Rezoning Transportation Analysis

Petition Number: 2018-073

From: Felix Obregon, PE
fobregon@charlottenc.gov
704-432-5729

Revision Log:

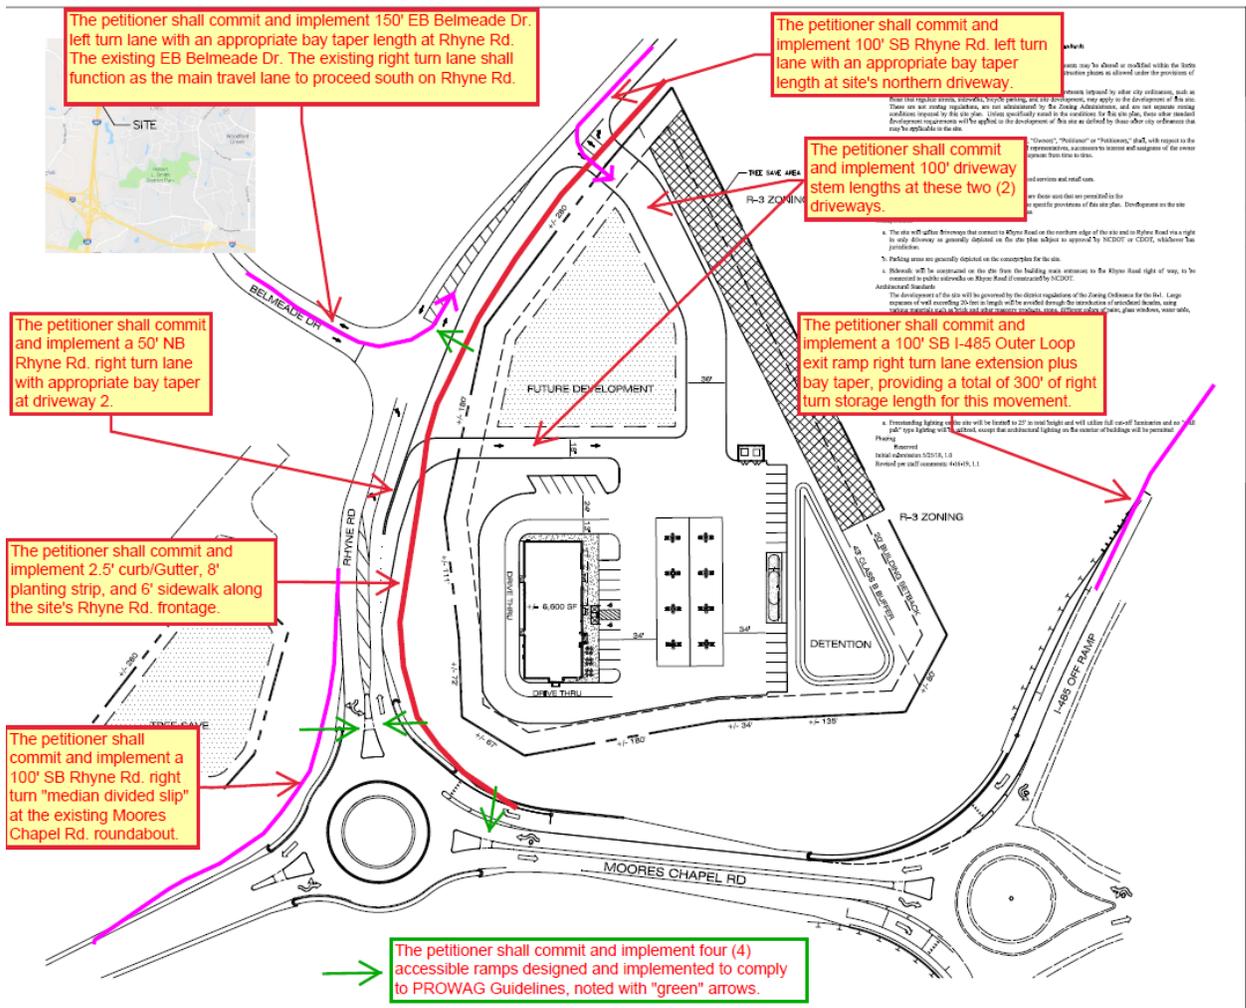
- Curbline** The proposed zoning district has a setback measured from back of the existing or proposed future curbline. The future back of curb locations are as follows:
 - ~~Moores Chapel Rd. is designated as a 4-lane divided minor thoroughfare with buffed bike lanes; therefore its future back of curb is 42' as measured from its proposed centerline (see below typical section).~~ **Comment rescinded.**
